# KALAMAZOO ROTARY STAGE

PROJECT: 98071

3/15/99 ISSUED FOR BID  
 5/7/99 RE-ISSUED FOR POST-BID ADDENDUM

ENTIRE SET REISSUED IN  
 POST-BID ADDENDUM #1

1 SOUTH ELEVATION  
SCALE: 1/4" = 1'-0"

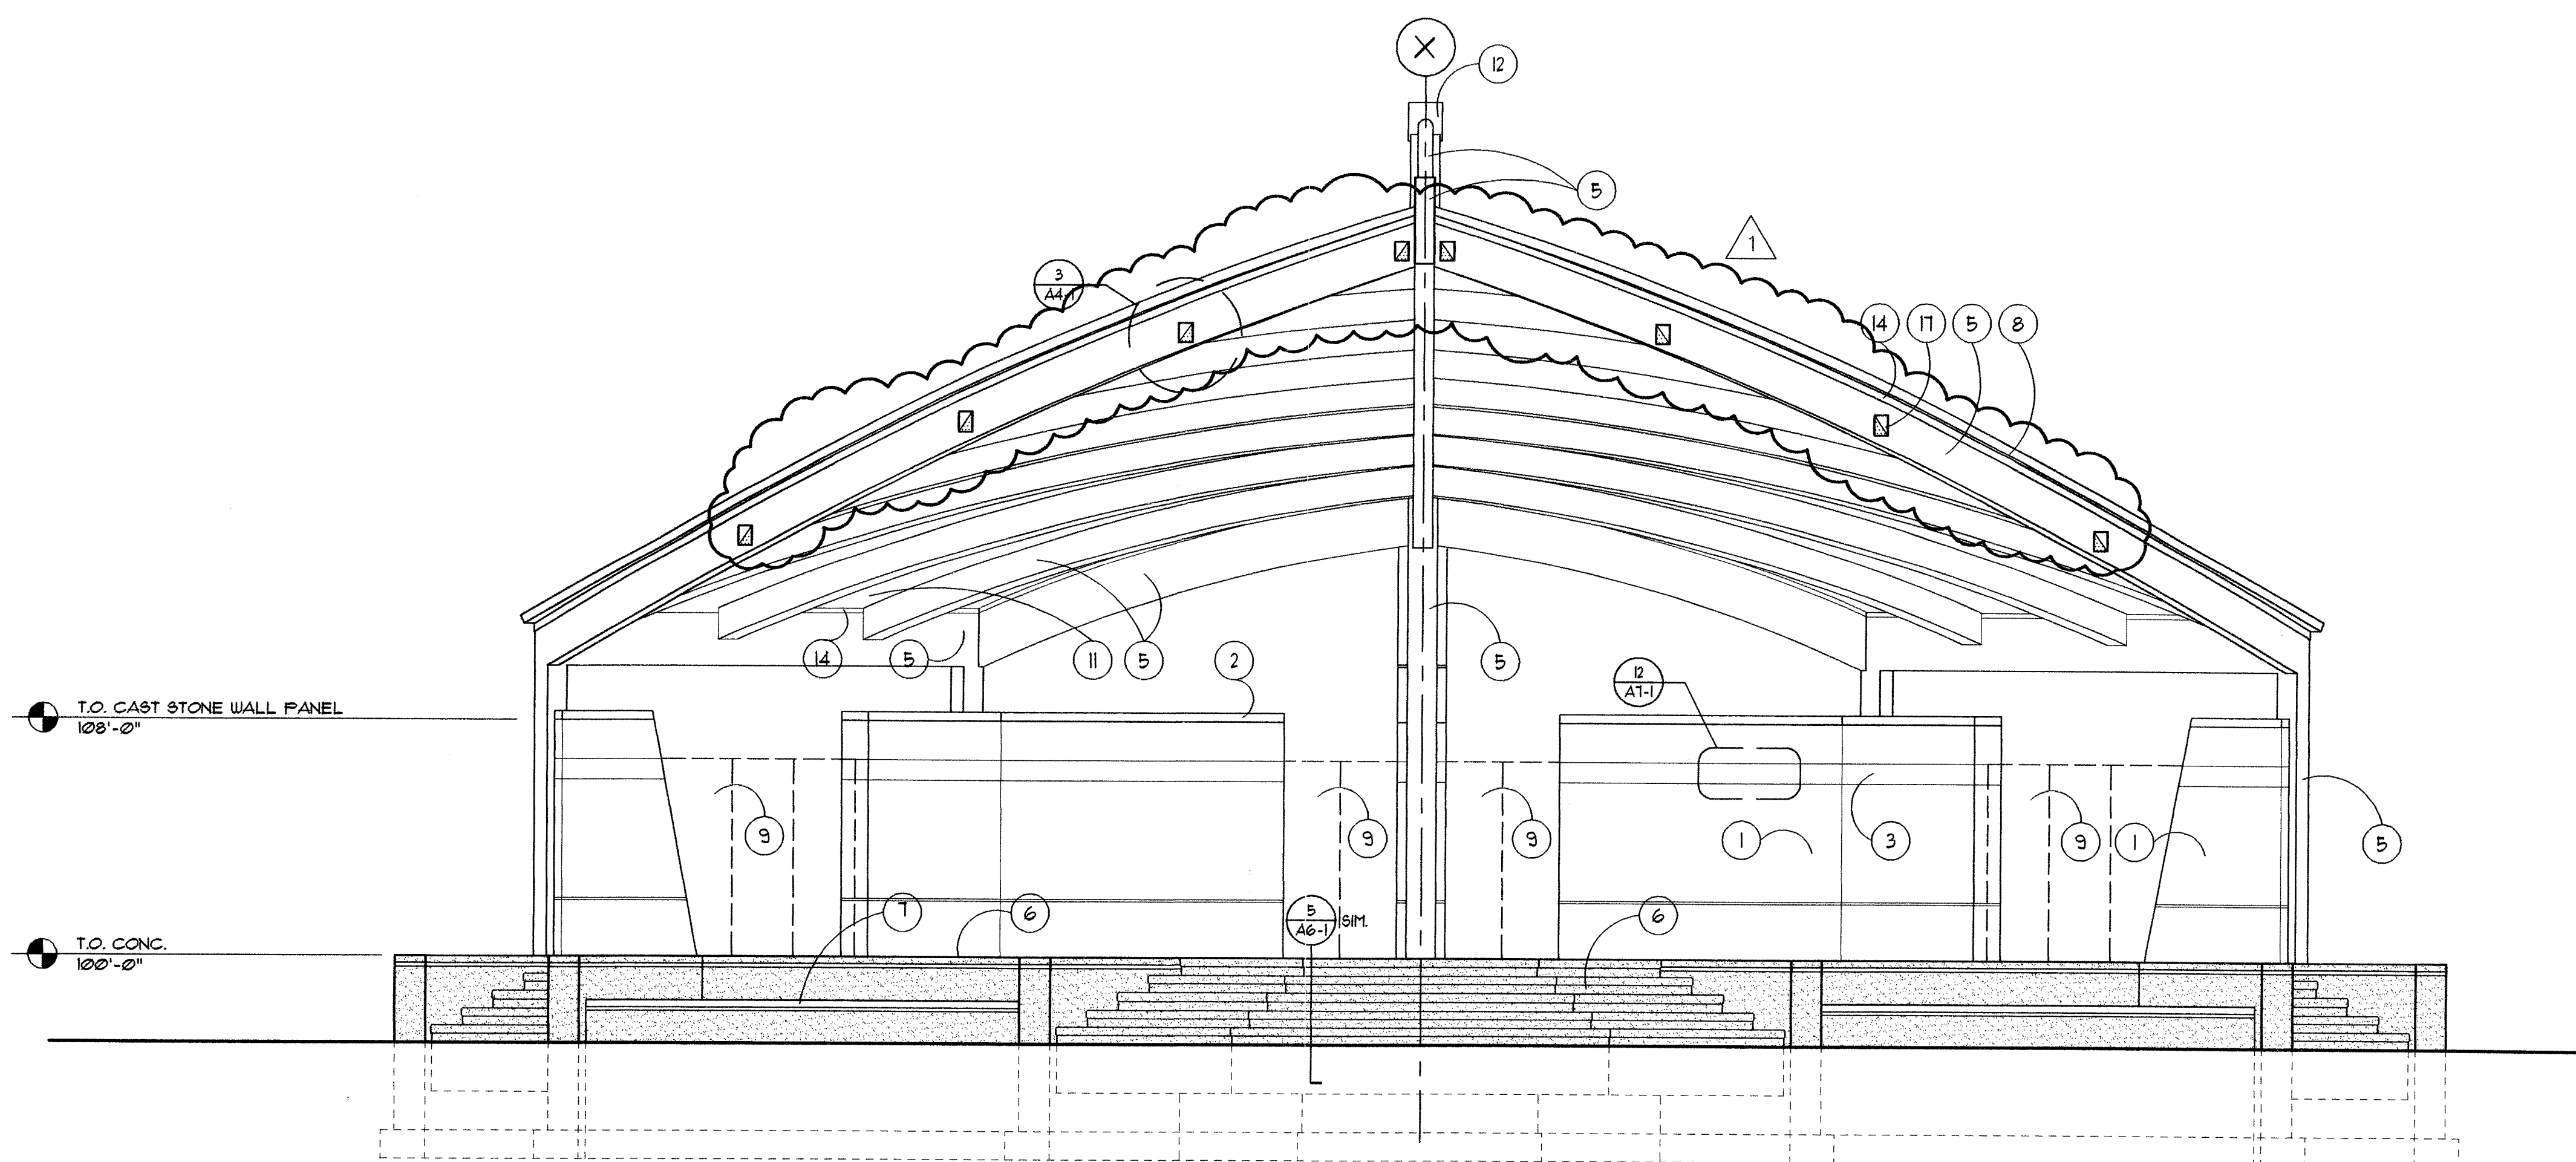
NOTE:  
ALL 3" LIMESTONE PANELS  
AND COPING HAVE BEEN  
CHANGED TO 3 1/2" CAST  
STONE MEMBERS. EXTERIOR  
FACES TO REMAIN IN SAME  
LOCATION ± ADDITIONAL 1/2"  
THICKNESS TO EXTEND INTO  
AIR CAVITY

1 NORTH ELEVATION  
SCALE: 1/4" = 1'-0"

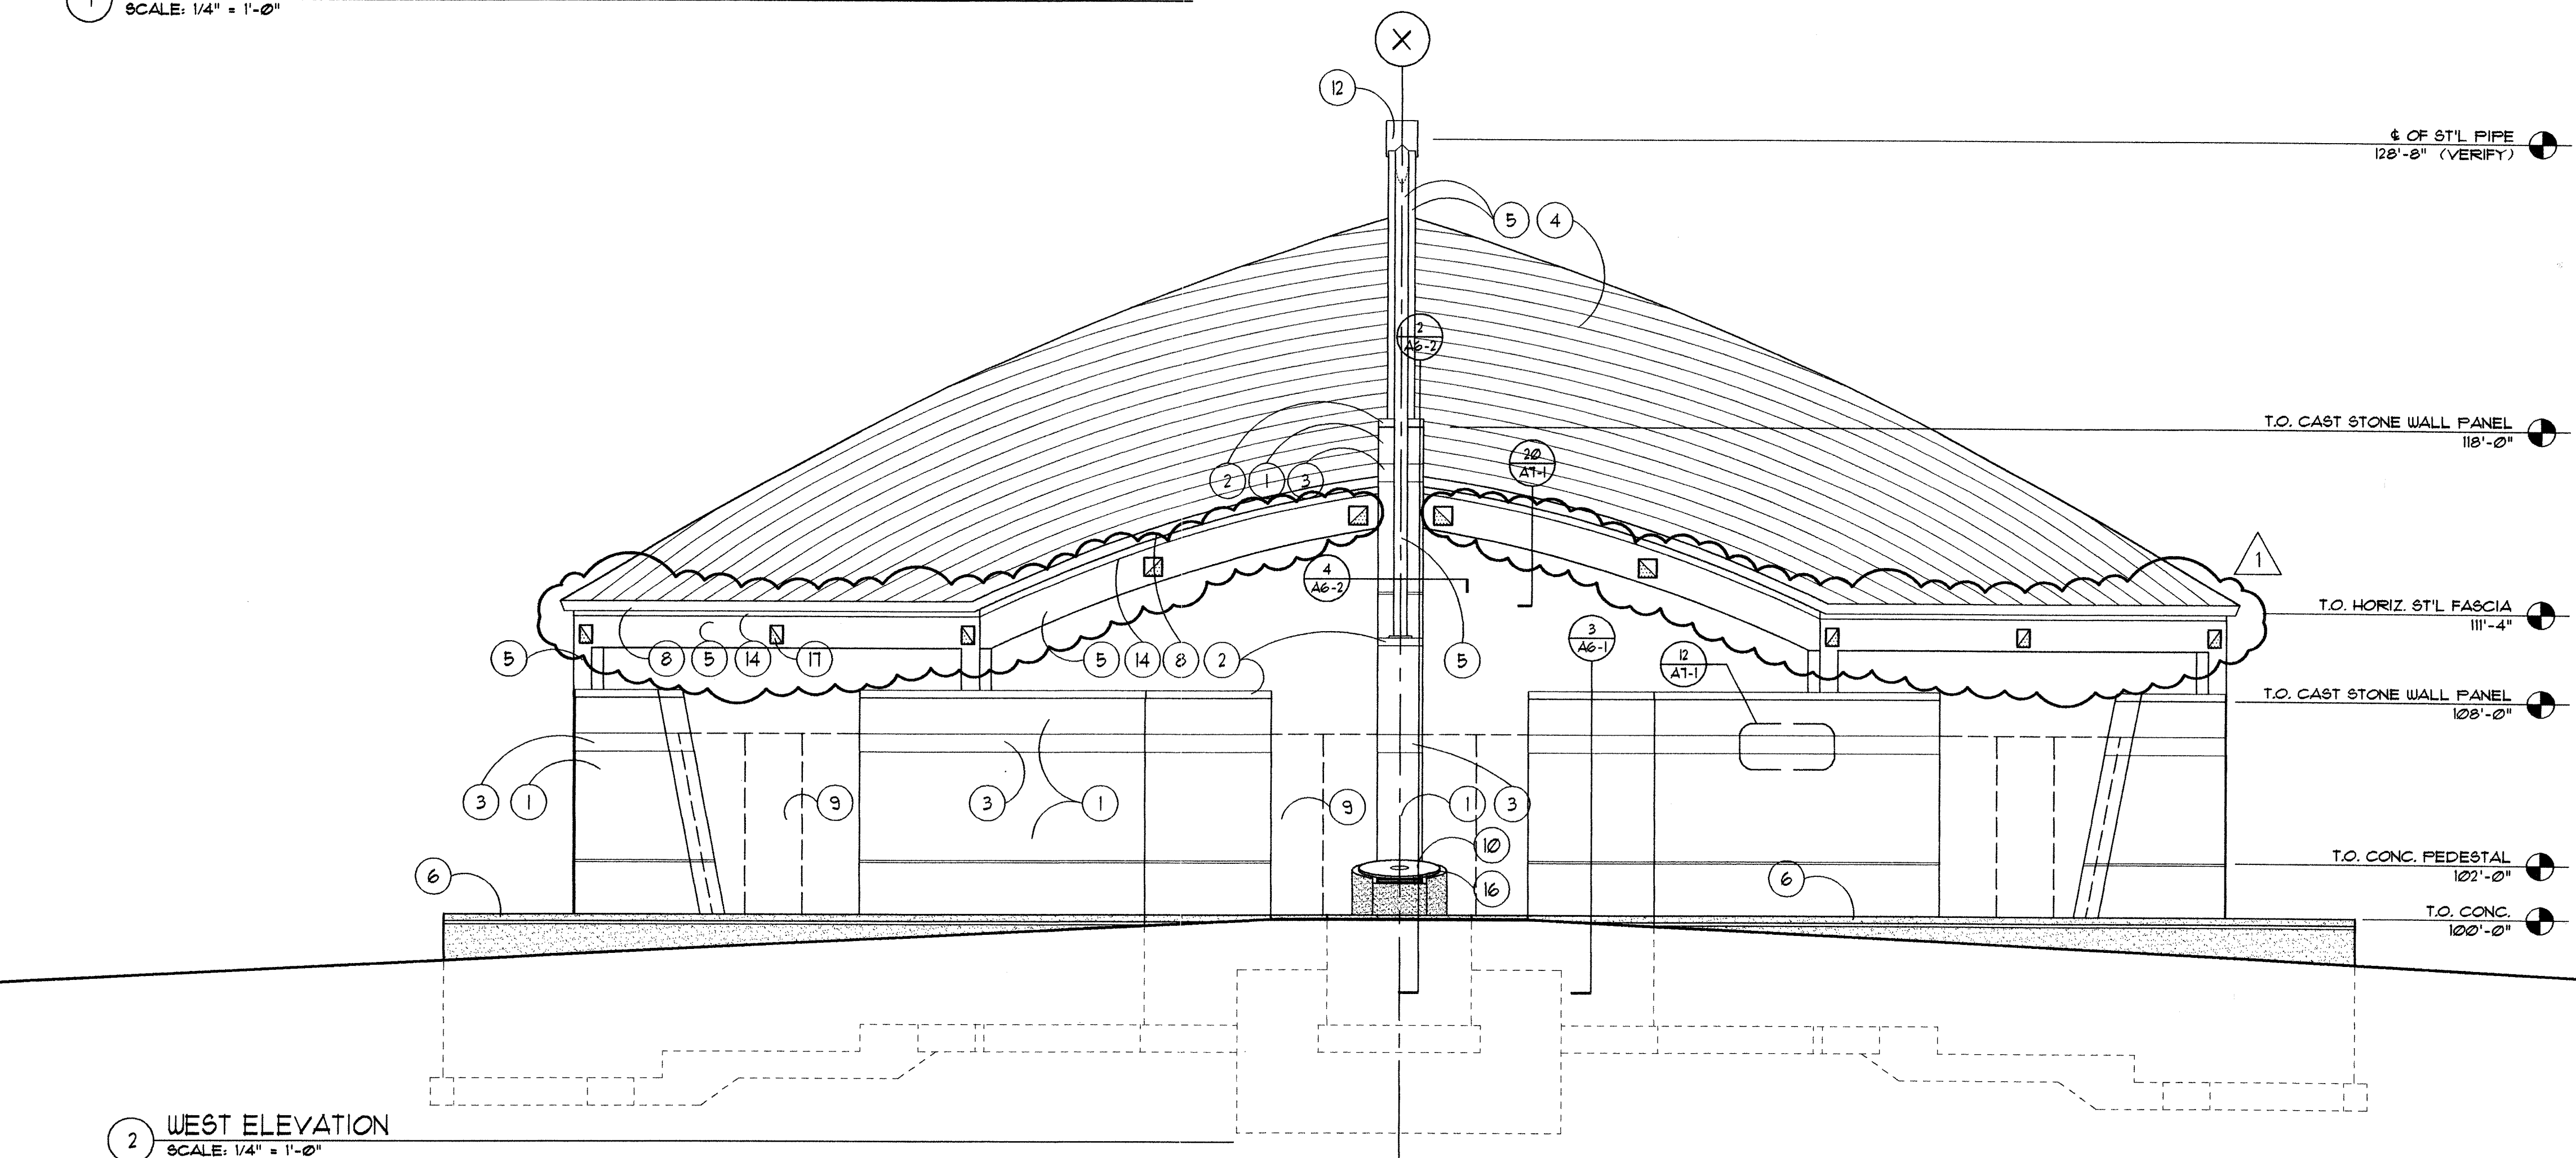
NOTE:  
ALL 3" LIMESTONE PANELS  
AND COPING HAVE BEEN  
CHANGED TO 3 1/2" CAST  
STONE MEMBERS. EXTERIOR  
FACES TO REMAIN IN SAME  
LOCATION± ADDITIONAL 1/2"  
THICKNESS TO EXTEND INTO  
AIR CAVITY

1 BUILDING SECTION

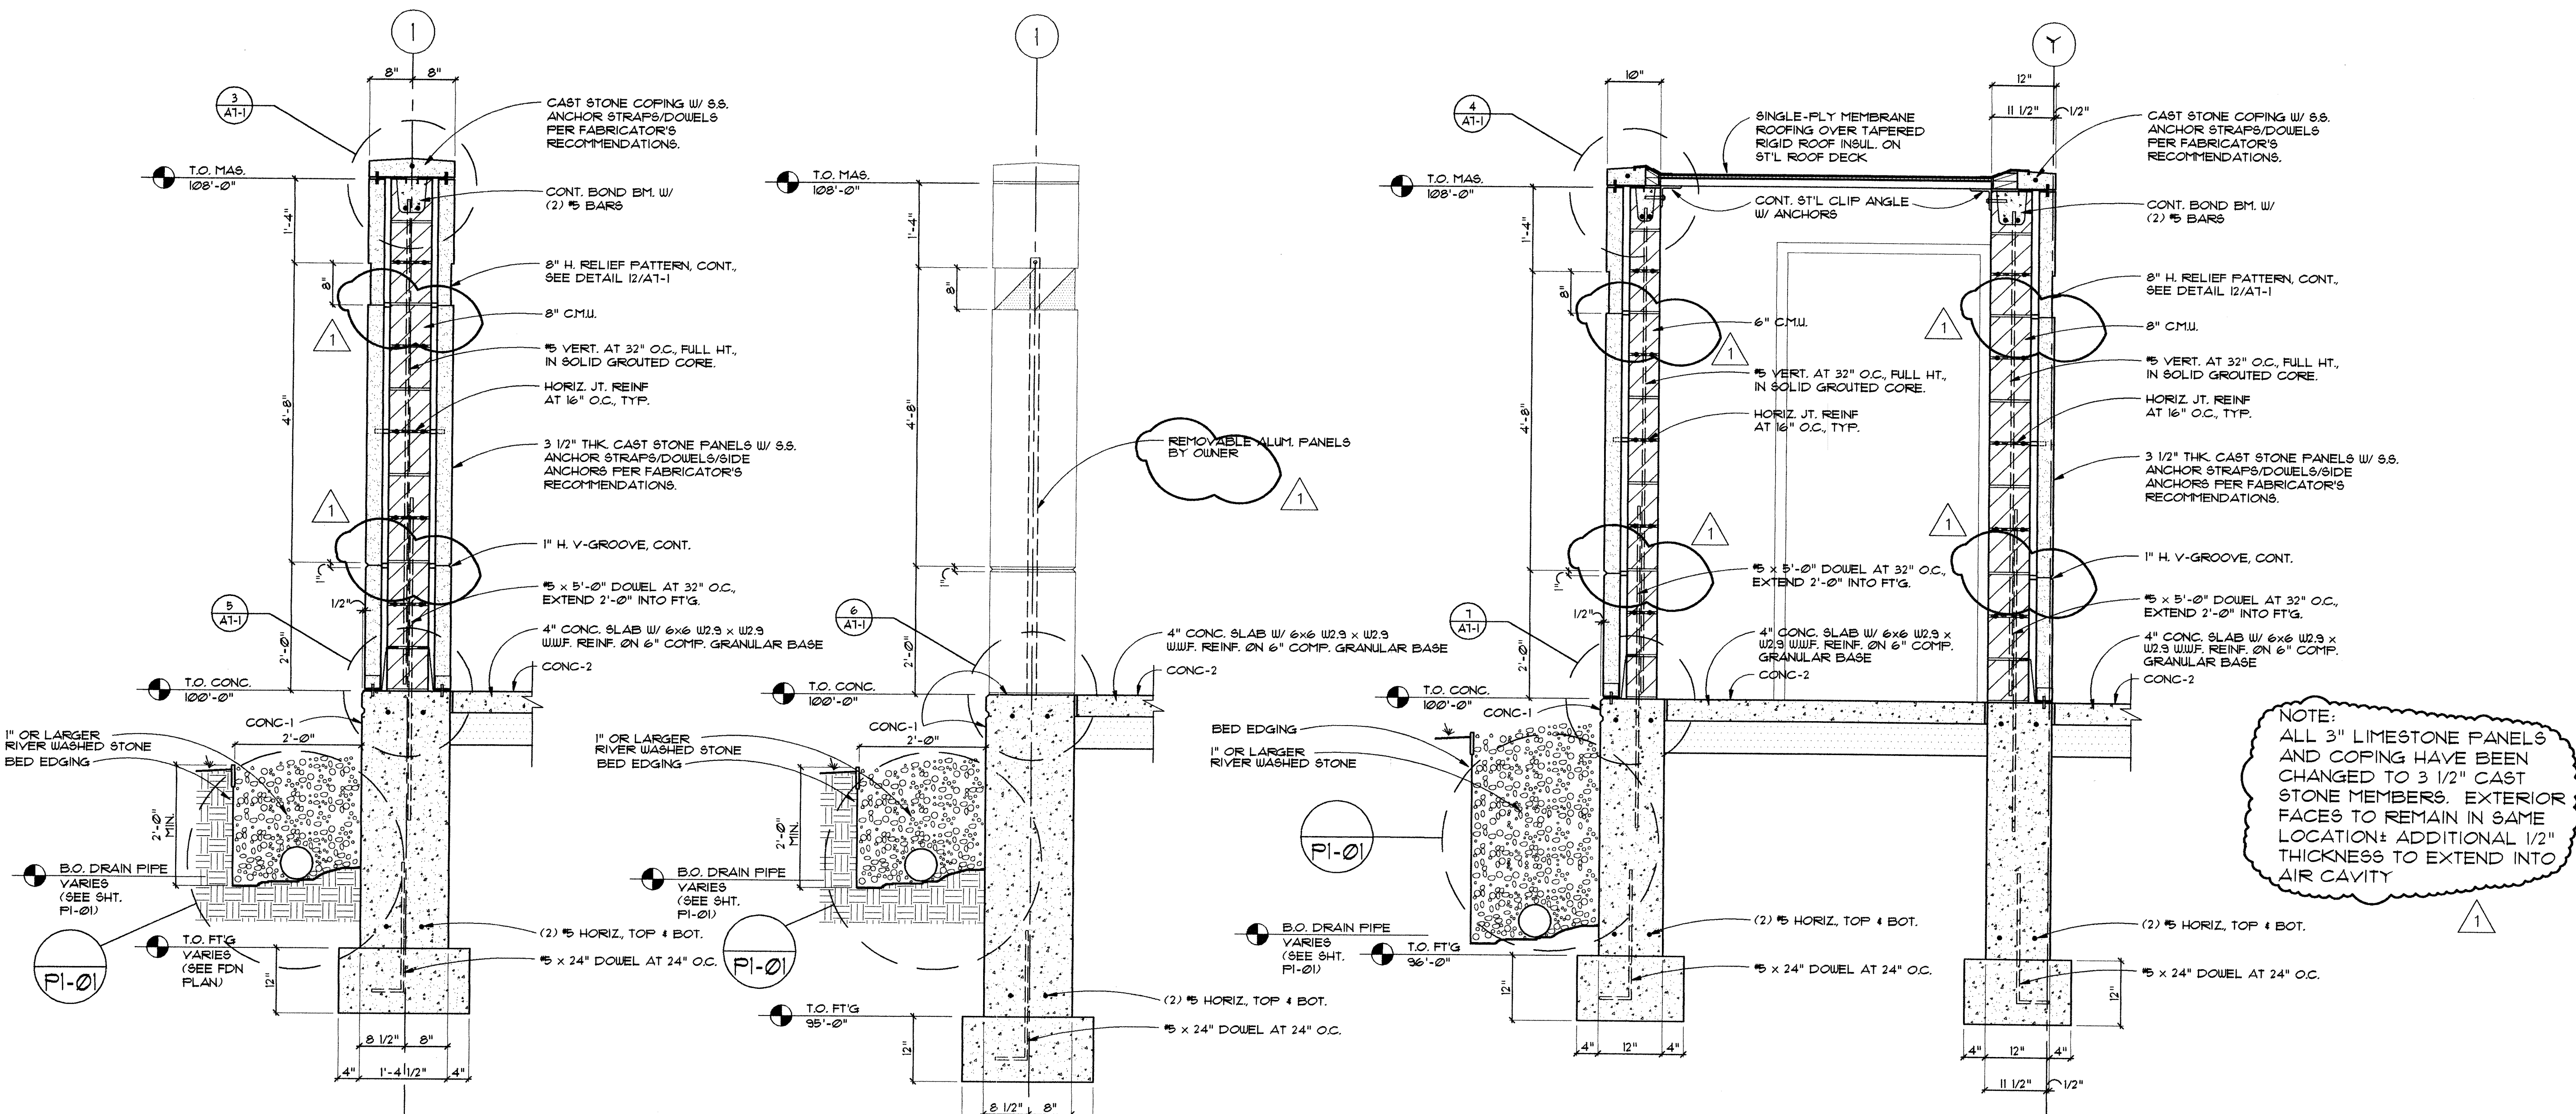
NOTE:  
 ALL 3" LIMESTONE PANELS  
 AND COPING HAVE BEEN  
 CHANGED TO 3 1/2" CAST  
 STONE MEMBERS. EXTERIOR  
 FACES TO REMAIN IN SAME  
 LOCATION± ADDITIONAL 1/2"  
 THICKNESS TO EXTEND INTO  
 AIR CAVITY
